AGENDA

ST. TAMMANY PARISH PLANNING COMMISSION MEETING 6:00PM – TUESDAY, JUNE 11, 2019 ST. TAMMANY PARISH GOVERNMENT COMPLEX PARISH COUNCIL CHAMBERS

ENTERING THE TAMMANY TRACE STAFF ANALYSIS REPORT (As of June 4, 2019)

CASE NO.: TRC19-05-001

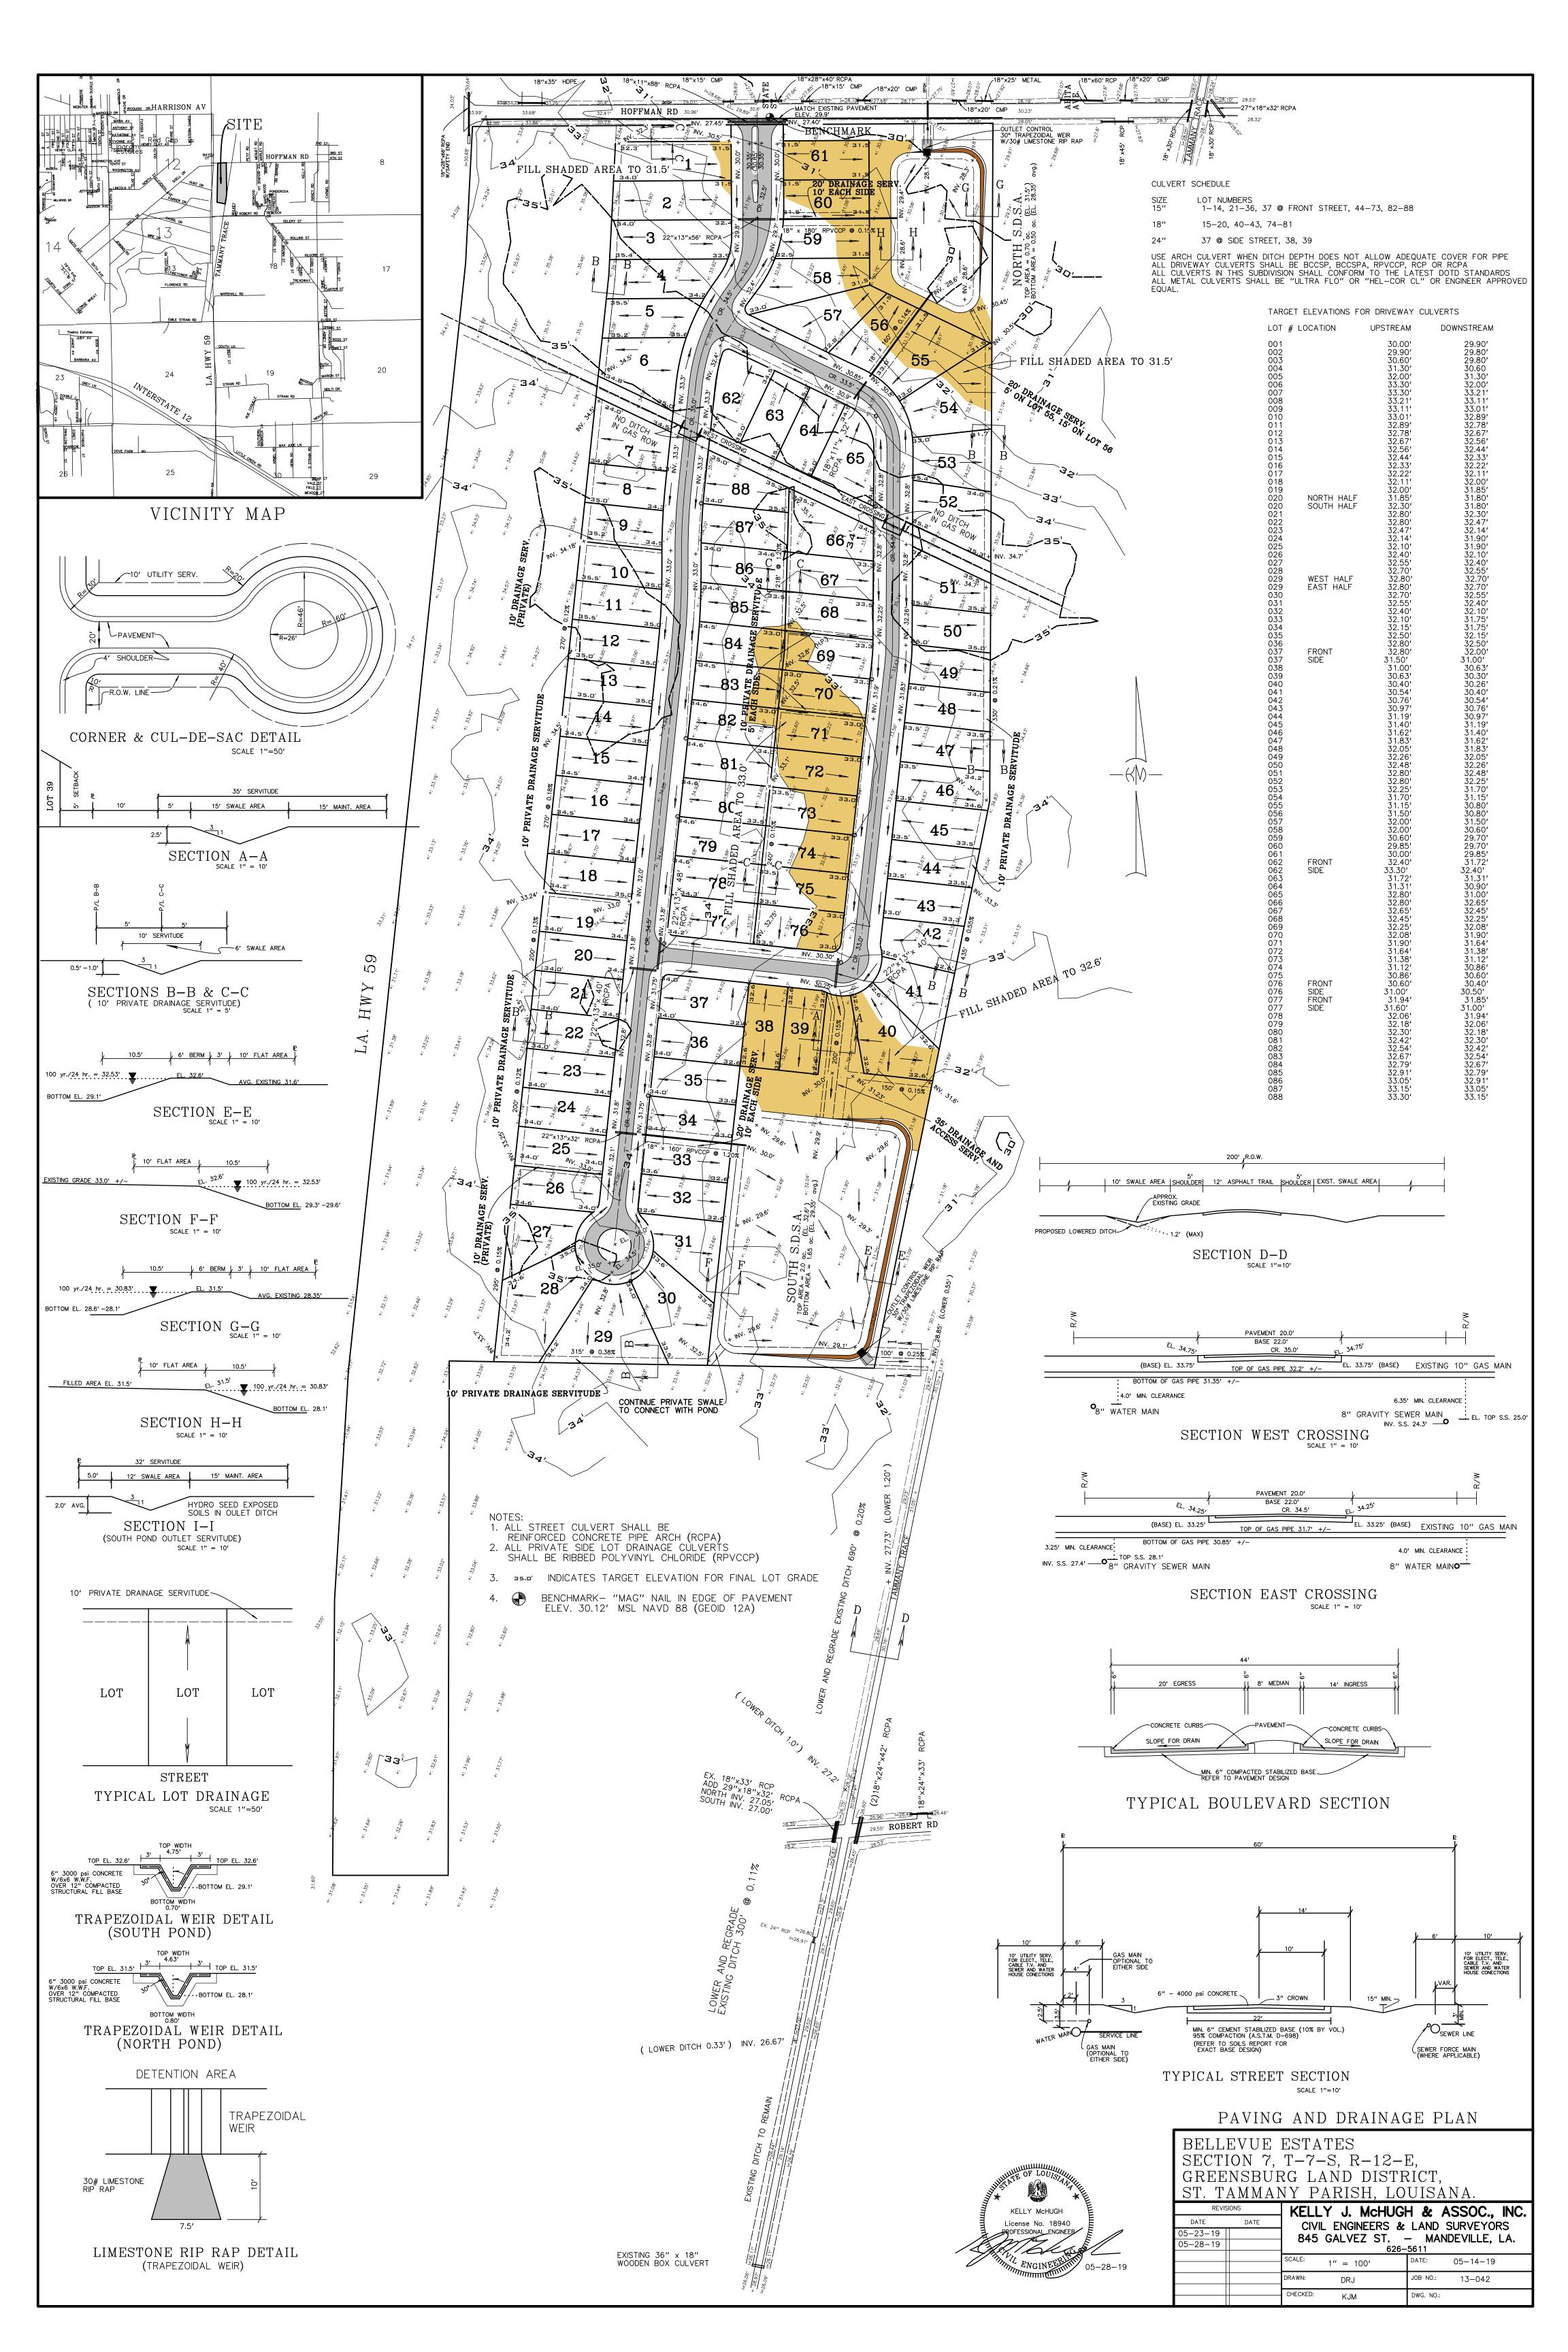
STAFF COMMENTARY:

The specific improvements are:

- 1. Construction of a 2' by 12' wide swale; 80' long from the southeast corner of Bellevue Estates to the western ditch along Tammany Trace.
- 2. Lower and regrade the western Tammany Trace ditch a maximum of 1.2' deep for a distance of 1350 feet south to a large box culvert that crosses the Tammany Trace.

- 1. The applicant shall procure written approval from the Director of the Tammany Trace prior to commencing any construction and shall provide said director with a daily work schedule.
- 2. The Tammany Trace shall not be closed or obstructed due to construction activity for more than one hour at any time unless it is approved by the Director of the Tammany Trace
- 3. Only rubber tire excavating equipment is to be used on the trace.
- 4. All construction activities on the Tammany Trace shall be limited to daylight hours, Monday through Friday only (no weekends).
- 5. The Tammany Trace must be kept clean and free of construction material and debris at all times.

- 6. All excavated material must be hauled off from site.
- 7. A land clearing permit must be acquired prior to work order and a pre-land clearing site visit will be conducted to ensure proper fencing or staking is in place to ensure no adverse effects on trees or Trace Right-of-Way.
- 8. The applicant shall provide the parish with a hold harmless agreement in favor of the parish subject to review and approval by the parish's legal department.
- 9. Provide subsurface drainage in lieu of open ditch for the 80' long portion of drainage improvement that extends from the southeast corner of Bellevue Estates to the western ditch of the Tammany Trace.
- 10. The applicant shall meet any and all requirements and stipulations pursuant to the Tammany Trace Ordinance.

BOUNDARY SURVEY OF:

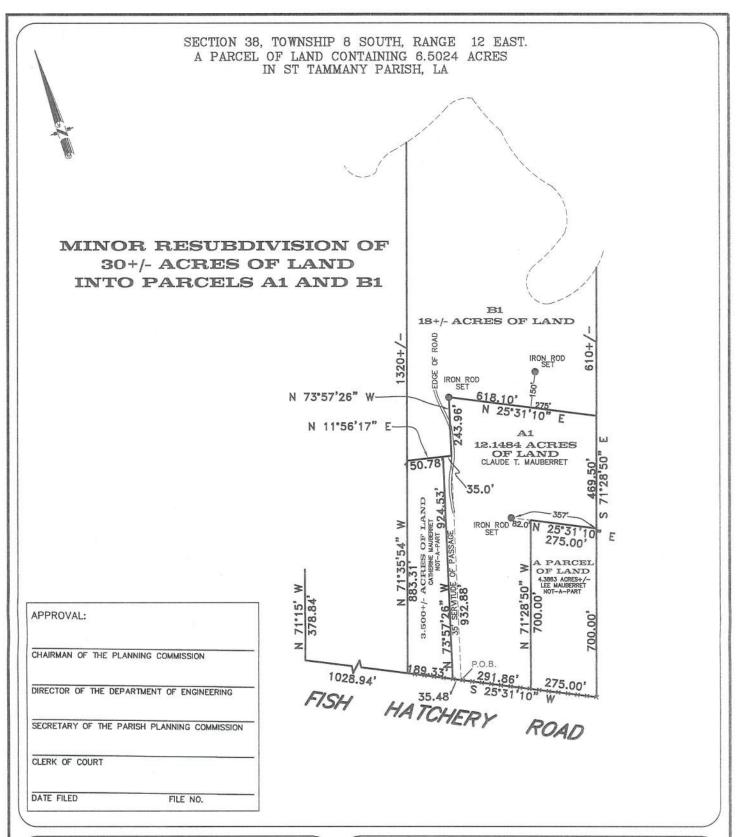
The applicant is requesting to create three (2) parcels from a 30.1484 parcel. The minor subdivision request requires a public hearing due to Parcel B1 not having public road frontage and being accessed via a 35' access servitude. The two proposed parcels meet the minimum requirements of Chapter 125-188 Minor Subdivision Review. Staff has no objection to the request subject to the following:

- 1. Correct the direction of the north arrow on the survey.
- 2. Label Bayou Lacombe on the survey.

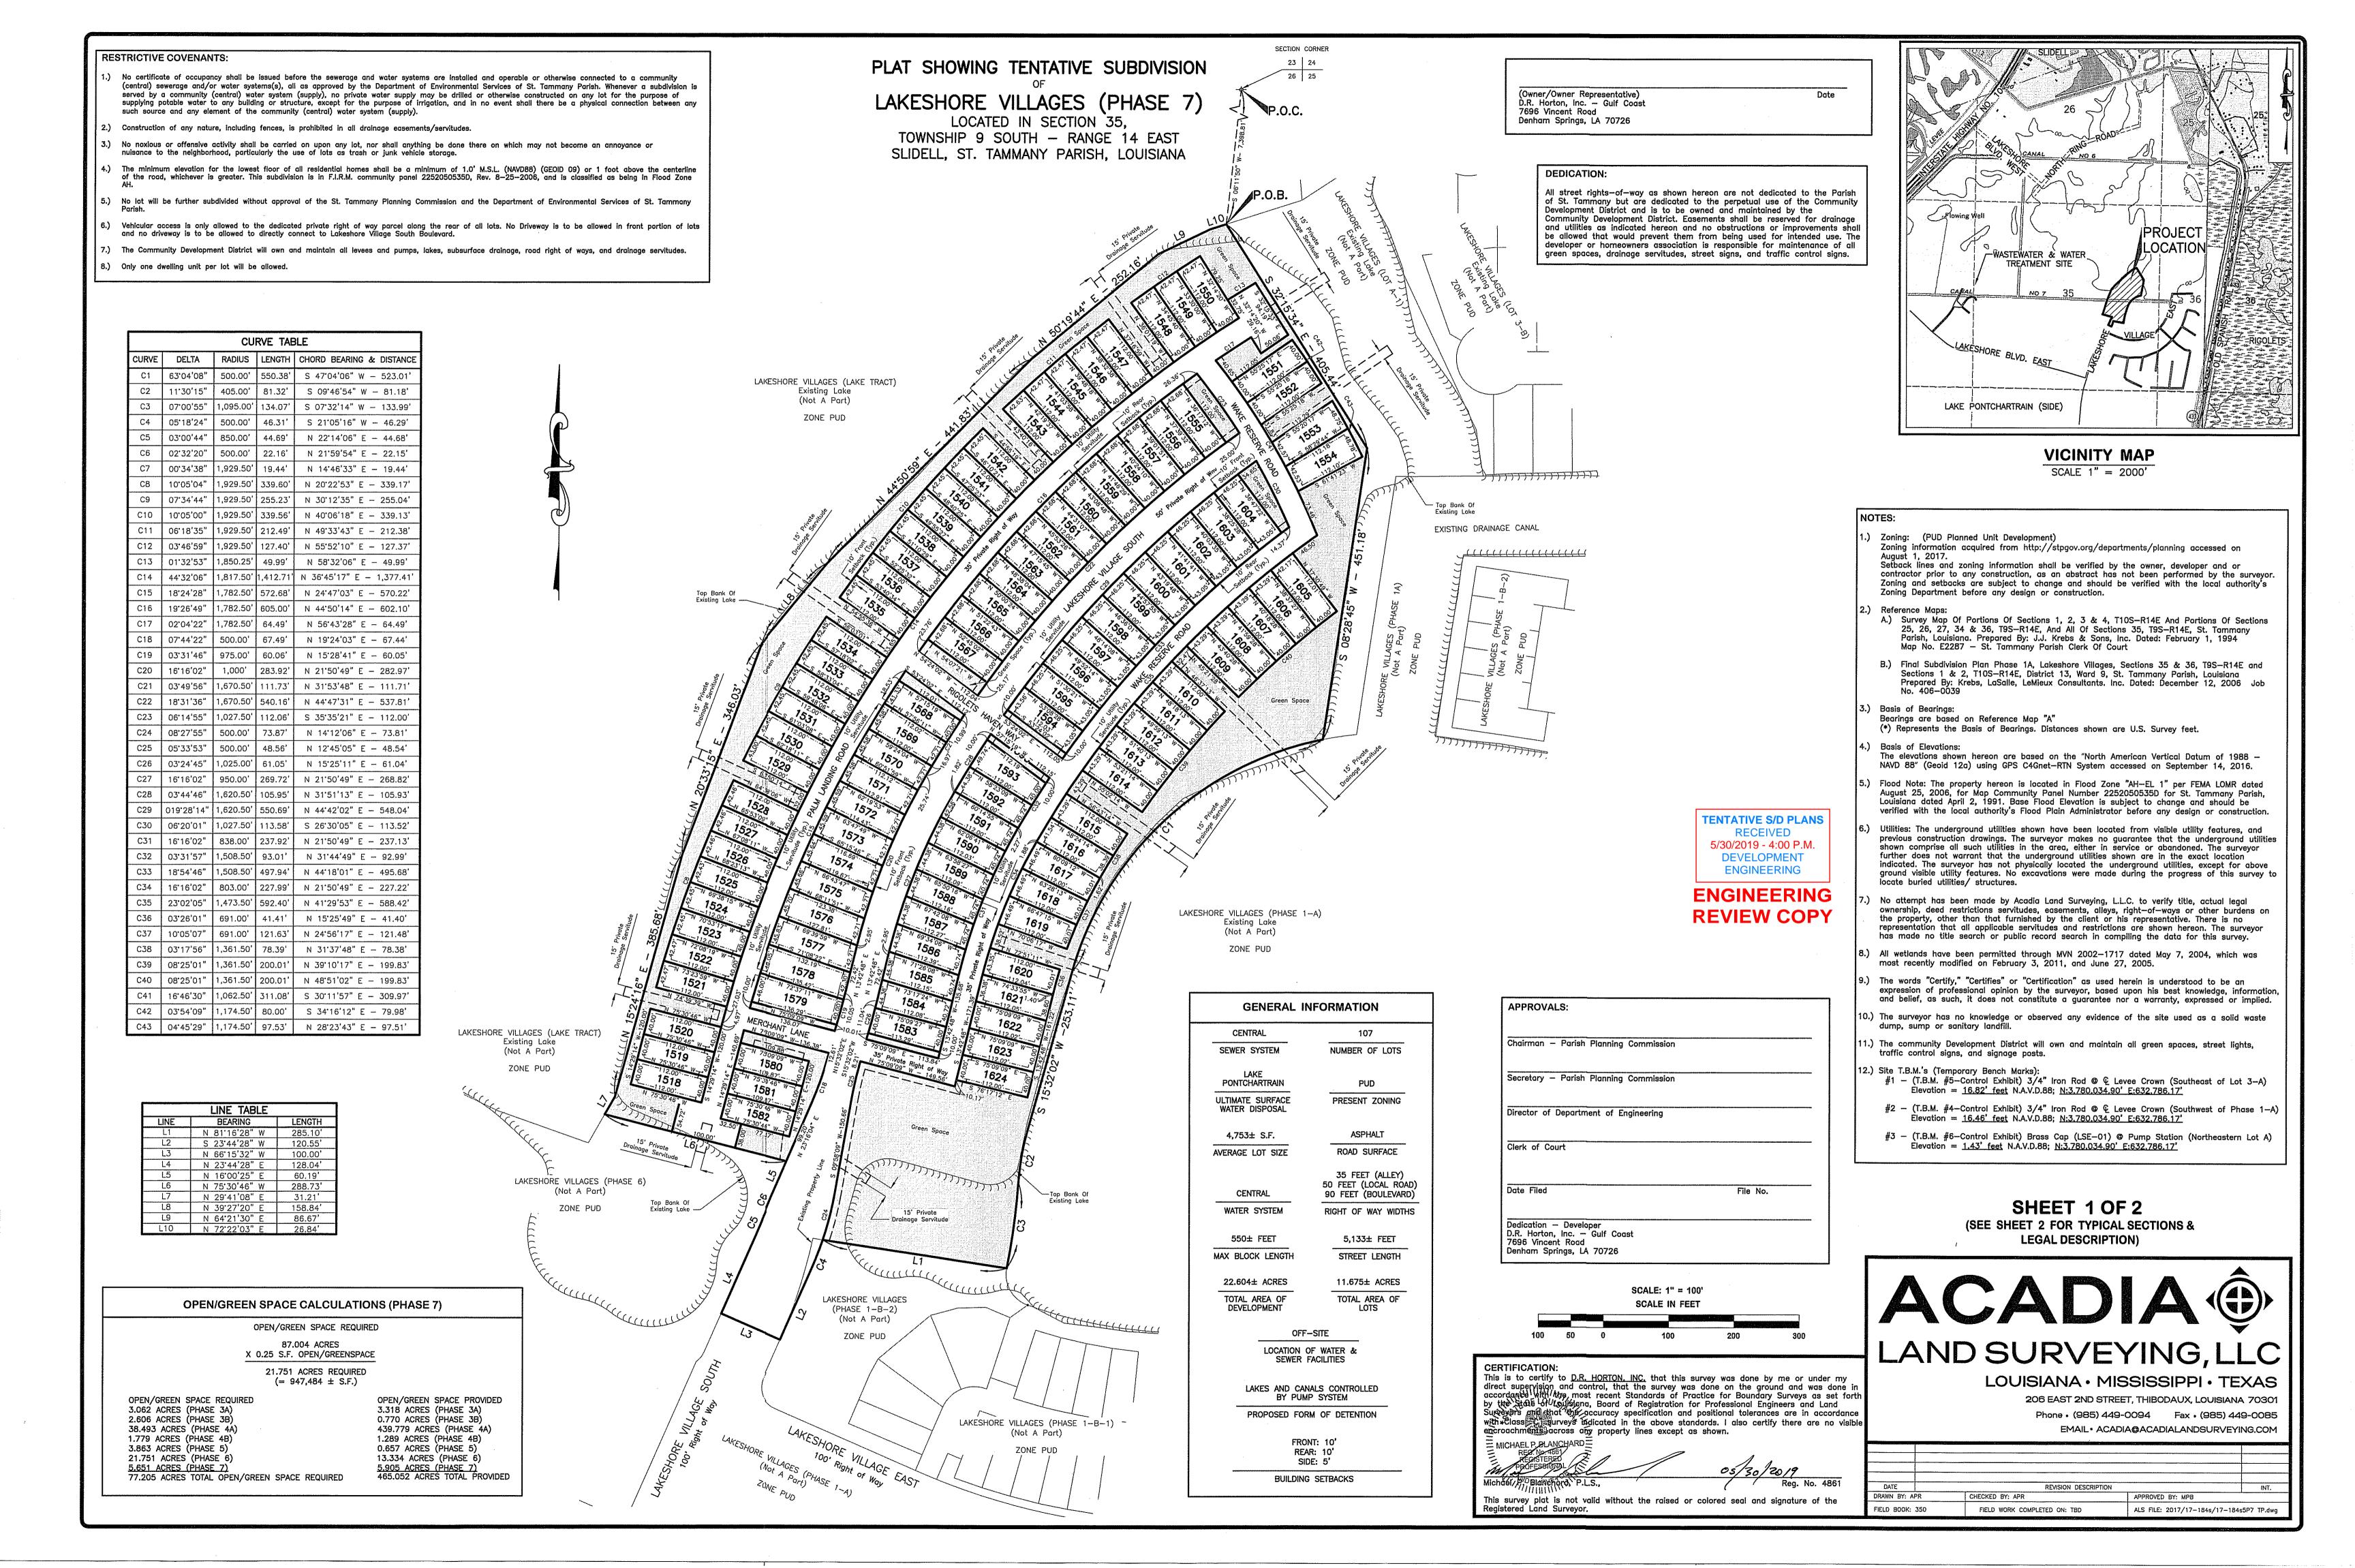
- 1. An updated Traffic Impact Analysis including Phase 7 of this development must be submitted and approved by St. Tammany Parish and LADOTD.
- 2. The request for inclusion of parking along Lakeshore Village South is currently under review and will require additional discussion between St. Tammany Parish and the Developer's Engineer.

3. A restrictive covenant regarding the placement of driveways in proximity of street right-of-way intersections needs to be added to the Tentative Plat. Upon review of the revised plat, it appears that nine of the corner lots do not meet the St. Tammany Parish requirement for, "driveways on corners lots shall not be located any closer than sixty (60') feet from a corner of said property closest to the intersection as measured from the property lines on the corner of the property where the said two street rights-of-way intersect. As such, a waiver of the minimum driveway requirement needs to be granted for phase 7 of this development. In order to approve this waiver request 2/3rds majority vote of the full membership of commission (8 members) is needed, pursuant to Section 125-244 Waiver of Regulations, of Chapter 125 – Subdivision Regulations.
